Intel Technical Advisory

TA1056-01

Potential system shutdown on the Intel[®] Server System P4000IP Family and the Intel[®] Server Chassis P4000M Family during certain RAID operations

Figure-3: Recommendation of the Power Rail Connection

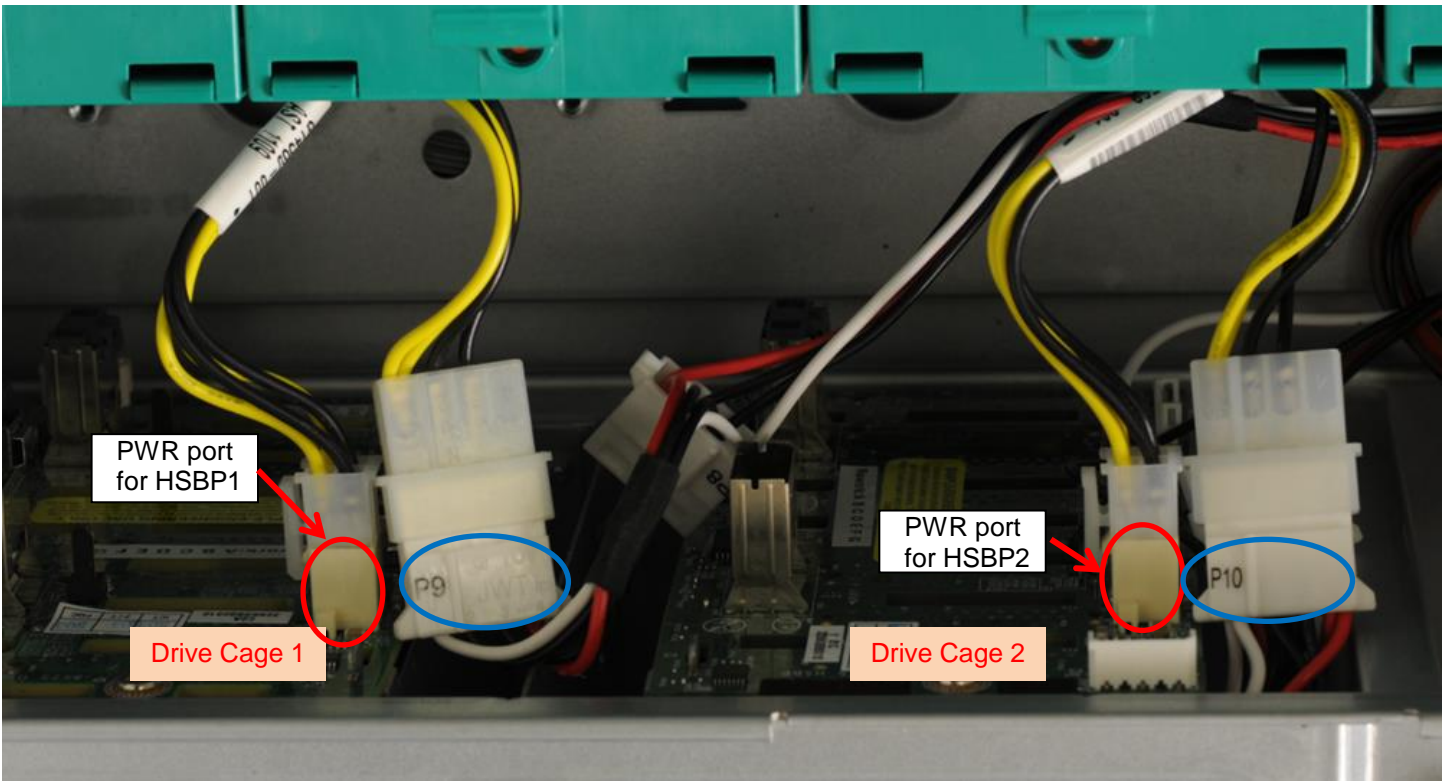
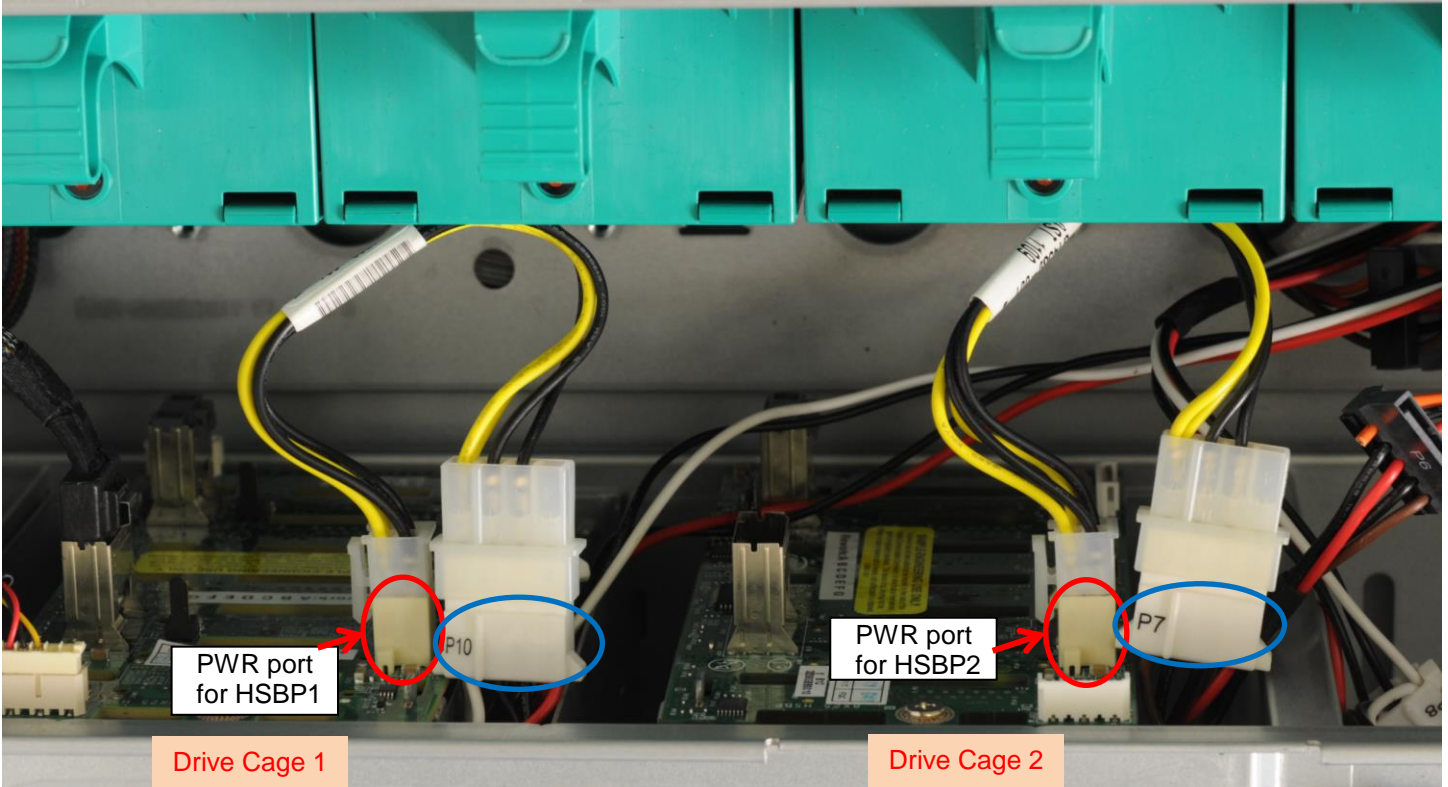
Scenario #	Scenario-1	Scenario-2	Scenario-3
Configuration	One additional Hot Swap Drive Cage Kit FUP8X25HSDKS is used to upgrade from 8x HDD configuration to 16x HDD configuration. The power connector P8/P9 (White) and P10/P11 (White) are connected to the HSBP-1 PWR port and HSPB-2 PWR port respectively (Figure-2).	The default configuration of two 8x 2.5" drive cages (16x HDD configuration). The power connector P8/P9 (White) and P10/P11 (White) are connected to the HSBP-1 PWR port and HSPB-2 PWR port respectively (see Figure-2).	One additional Hot Swap Drive Cage Kit FUP8X25HSDKO is used to upgrade from 16x HDD configuration to 24x HDD configuration.
Affected Products	FUP8X25HSDKS	P4216IP4LHJC P4216IP4LHKC P4216XXMHJC P4216XXMHGC P4216XXMHGR	FUP8X25HSDKO
Corrective Action	Reconnect the power connector P10 to the HSBP-1 PWR port and the power connector P7 to the HSPB-2 PWR port (Figure-3).		Intel will provide an updated PDB to customers starting from May 5 th , 2014. Please indicate you are calling regarding TA-1056-01, and have the following information when you call: serial number(s) for the system(s) needing the replacement part. You can refer to the related products service guide for how to replace the PDB. The Service Guide is available on http://www.intel.com/support/motherboards/server/sb/CS-033321.htm
